South Texas Project Electric Generating Station P.O. Box 289 Wadsworth, Texas 77483

September 29, 1998  
NOC-AE-0231  
File No.: G20.02.01  
G21.02.01  
10CFR50.90

South Texas Project  
Units 1 and 2  
Docket Nos. STN 50-498 and STN 50-499  
Proposed License Amendment Associated with Revised Calculation Methodology  
for Loss Of Coolant Accident Mass and Energy Release Analysis

**FIGURE 1**

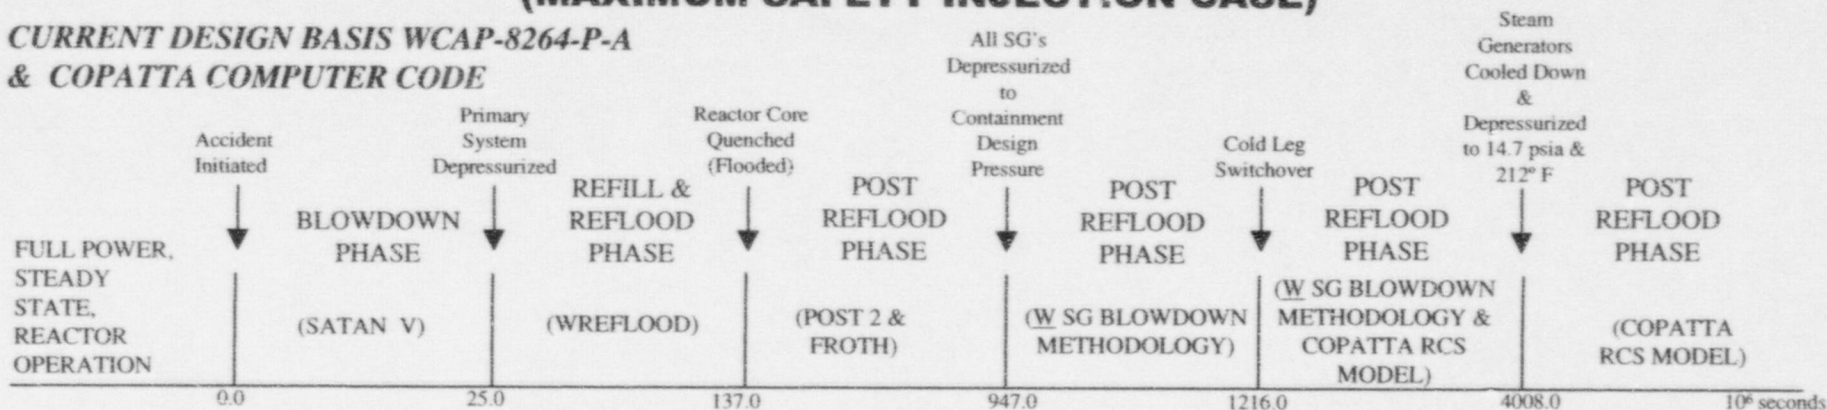
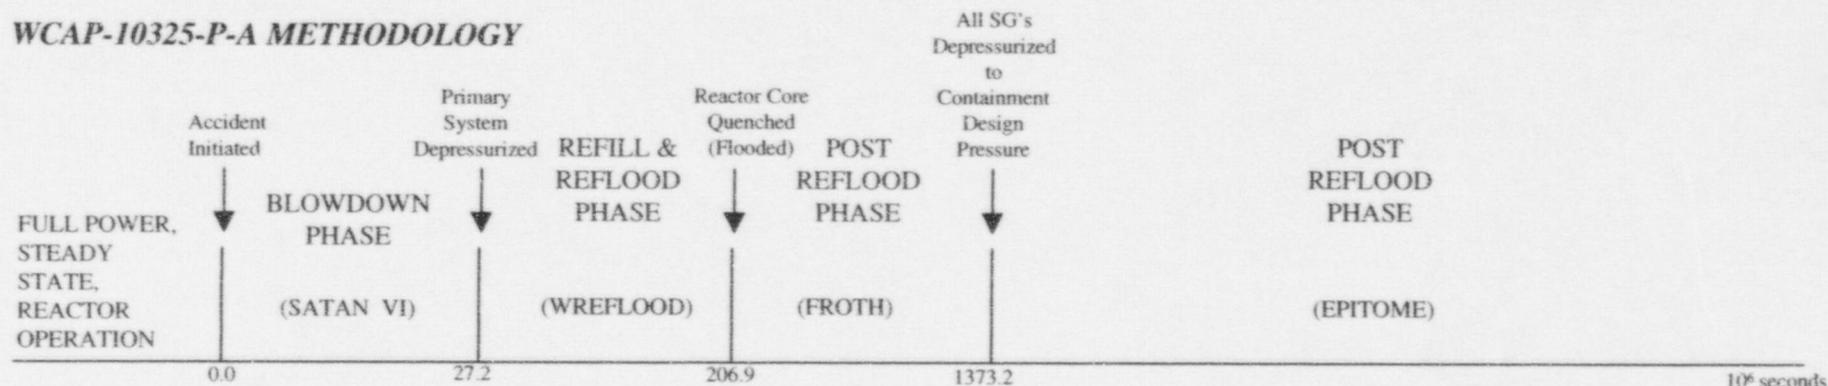
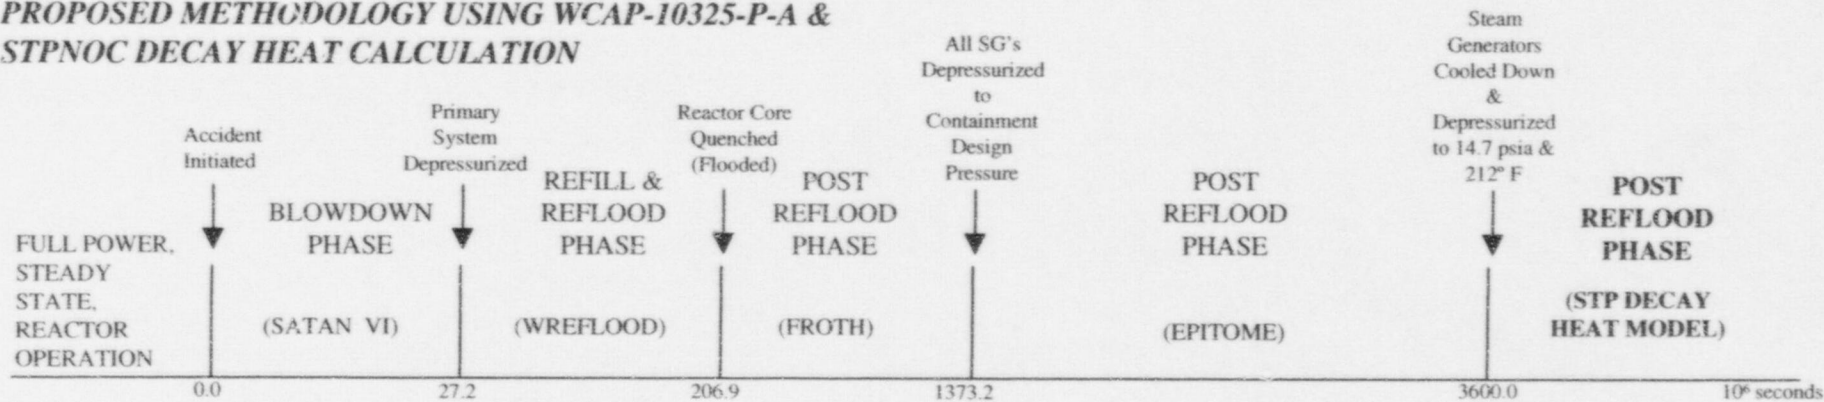
Note: Figure 1, found at the end of this attachment, provides an event related comparison of the following discussion of post accident phases, showing currently approved analysis methodology vs. proposed methodology.

Figure 1 provides three time lines for the limiting case of a Double Ended Pump Suction Guillotine Break with maximum safety injection (LOCA-2). These time lines compare analyses for:

- the Model E steam generator using WCAP-8264-P-A methodology,
- the  $\Delta 94$  steam generator analysis using WCAP-10325-P-A, and
- the  $\Delta 94$  steam generator analysis using WCAP-10325-P-A with STPNOC modification.

FIGURE 2  
COMPARISON OF MODEL E & DELTA-94 SG PRESSURE TRANSIENTS  
(DEPSG Breaks with Max SI & Min CHRS)

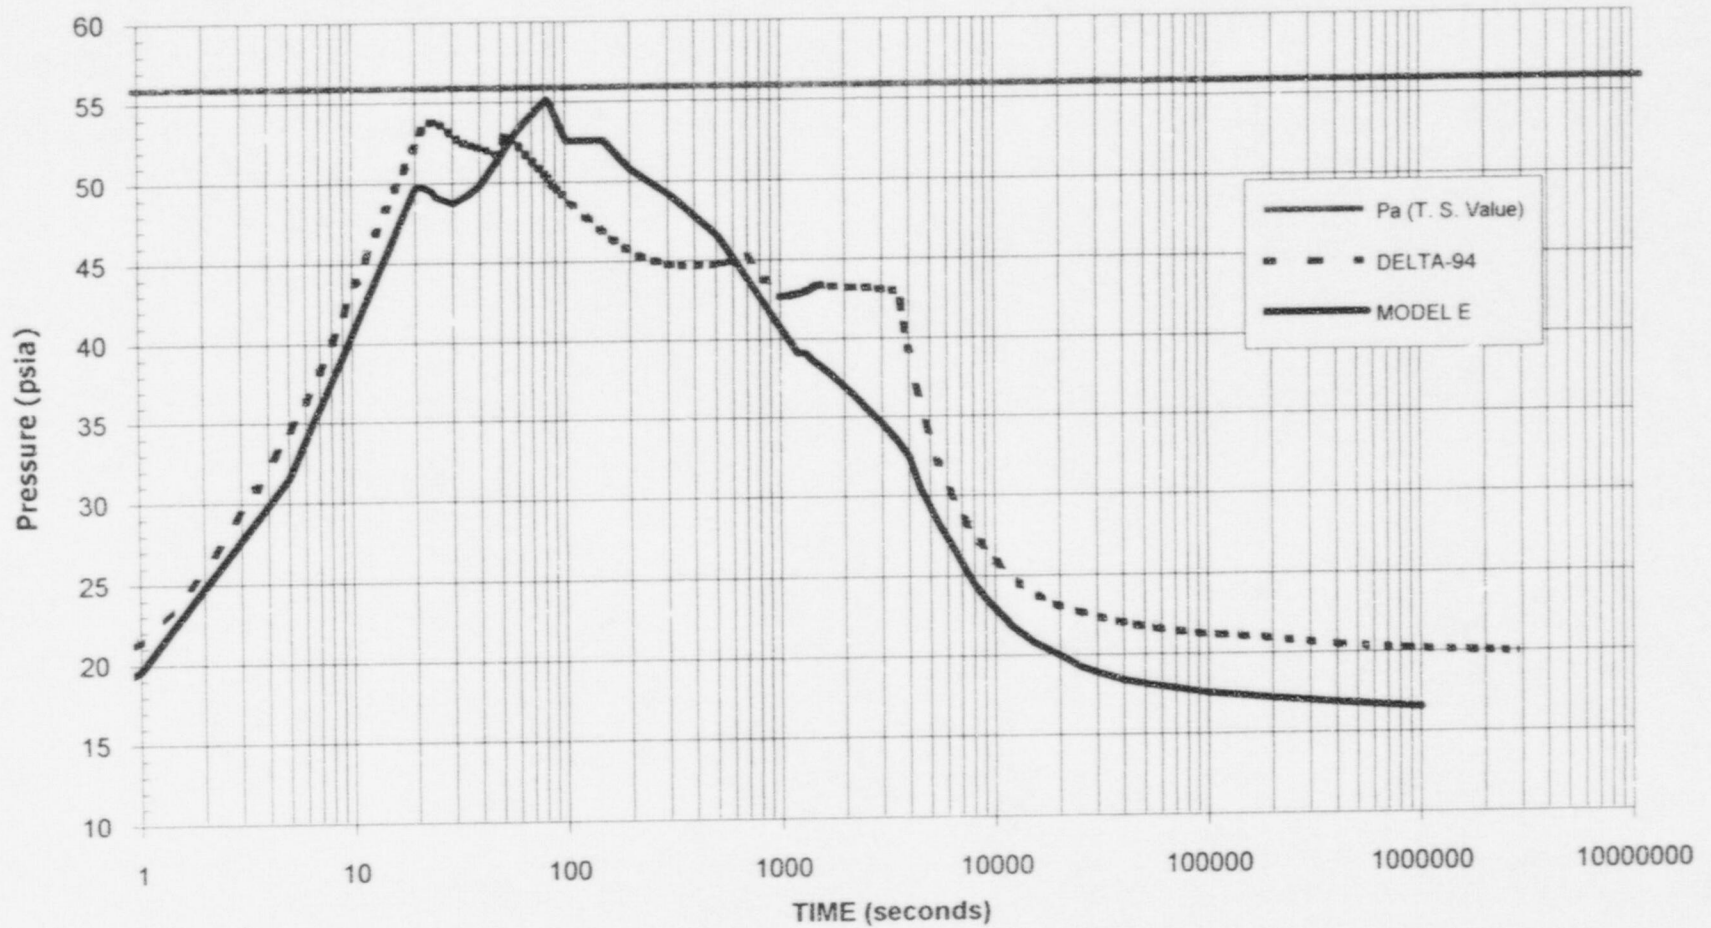
Figures 2 and 3 show comparative Model E and  $\Delta 94$  steam generator analysis Containment Pressure and Temperature response during the limiting design basis accident, using currently approved methodology and proposed methodology.
